**Portion 2898 & Section 3115 (92 & 102) Reichardt Road, Winnellie – Hundred of Bagot
Changes to the Development Approved by DP05/0015 to Reduce the Number of Lots from 72 to 68**

**Lots 1972 - 1977 (46 & 44) Stuart Highway, (2 & 4) Henry Street, (1 & 3) James Street, Stuart Park – Town of Darwin
New Showroom Sales Building and Associated Carparking**

GROUND FLOOR PLAN.

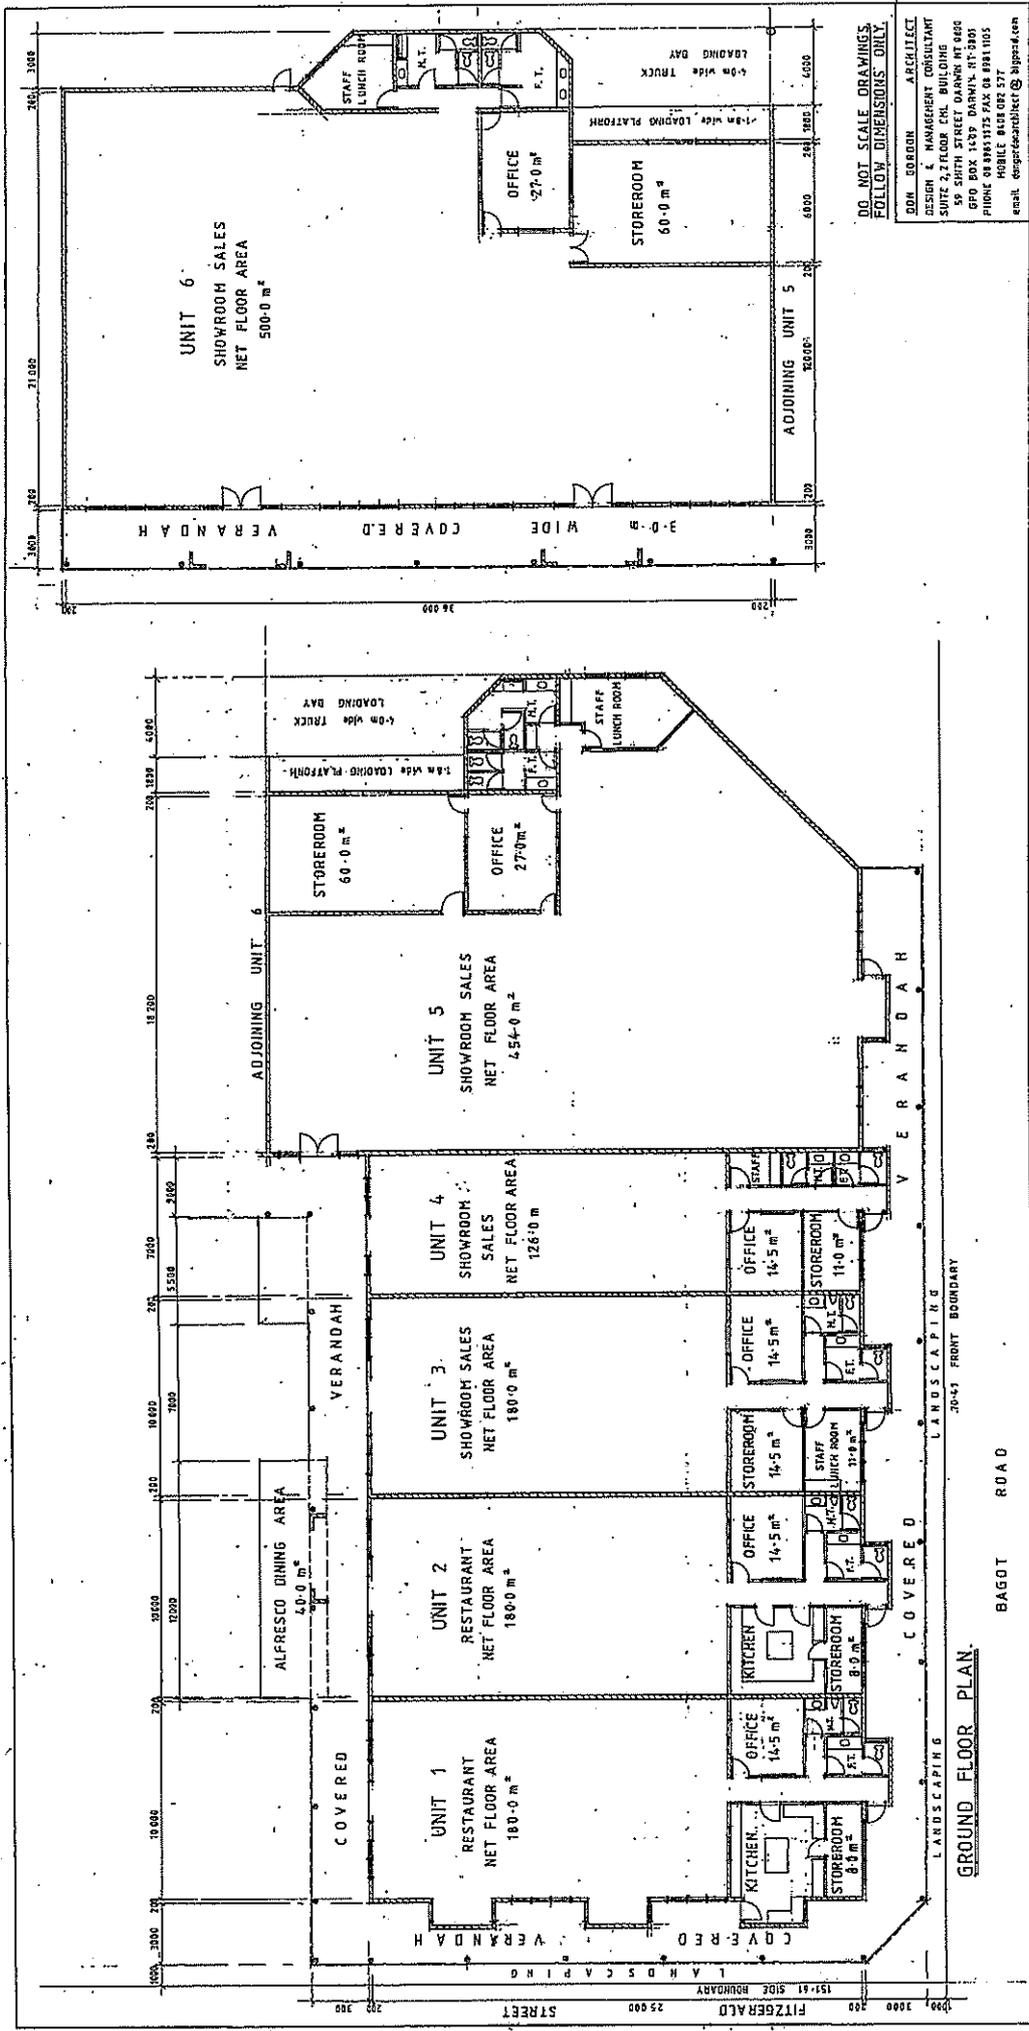
- a). **Council requests the Authority requires a schematic plan to demonstrate how stormwater will be collected on the site and discharged underground to the stormwater drainage system.** The applicant's plans fail to demonstrate how on-site stormwater will be collected and discharged underground to the drainage network. Council requires the plan to confirm that it is technically feasible to collect stormwater on the site and dispose of it into the stormwater drainage system.
 - 1). The plan shall include details of site levels and stormwater drain connection point/s within the vicinity of the site.
 - 2). It is necessary to ensure that no stormwater will sheet-flow into the road reserve or onto adjoining properties.

- b). **Council requires commercial premises to have on-site dedicated waste bin and recycling storage enclosures, and separate facilities for food waste from restaurants.** Council notes that the '*Location, Site and Ground Floor Plan*' includes a waste bin storage area adjacent to the vehicle entrance from Fitzgerald Street. The technical specifications for the proposed waste bin and recycling storage enclosure will need to be assessed and approved by Council's Environment Manager. Council's Environment Manager will require additional information to demonstrate that the proposed enclosure is large enough to store the number of bins required for a commercial development of this size and also information to demonstrate that a commercial bin service vehicle can safely access the bin store to service the bins. The bin enclosure should also be appropriately screened. The applicant is invited to contact Council's Environment Manager on 8930 0530 to discuss waste management issues for the development.

- c). **Council requests the Authority requires amended plans demonstrating driver sightlines from the vehicle exit driveways to Fitzgerald Street and Bagot Road.** To ensure pedestrian safety on the foot path, sightlines are to be integrated into the on-site design of the development to ensure that drivers exiting the car parks can see pedestrians on the footpath. No wall, fence or tree exceeding 0.6 metres in height should be constructed or planted in front of the sight line. The applicant's site plan shows landscaping adjacent to the vehicle exits, but fails to provide details of the species to be planted.

The submitted plans indicate that signage will be displayed within the site boundary. The *Location Plan* indicates a structure at the corner of Fitzgerald Street and Bagot Road and the *Typical Section of Units Plan* demonstrates an approximate 9 metre high, 3 metre wide signage 'obelisk' style sign on the Bagot Road frontage of the site, adjacent to the vehicle exit.

- a). **The existing vehicle crossover and driveway to the site from Fitzgerald Street appears to meet Council's requirements.** The applicant's plan notes that this driveway is 8.0 metres wide. There is also a vehicle exit to Bagot Road. Bagot Road is maintained by the Northern Territory Government.

- b). **Council requests that the Authority requires additional information from the applicant regarding the car parking assessment for the proposed development, to demonstrate that adequate car parking is to be provided on the site.** The development application submission fails to provide any detail of the car parking calculation method. Council has noted that applicant's submission states that the 2 restaurants have a gross floor area of 360m² and the alfresco dining area is 40m². The Ground Floor Plan however, shows a total gross floor area of 500m² for the restaurants. In addition, the applicant is counting the restaurant loading bay (bay 84) as a car parking space. It would not be appropriate for any vehicle to park in bay 84 whether for loading purposes or car parking as it would block access to the waste bin enclosure.
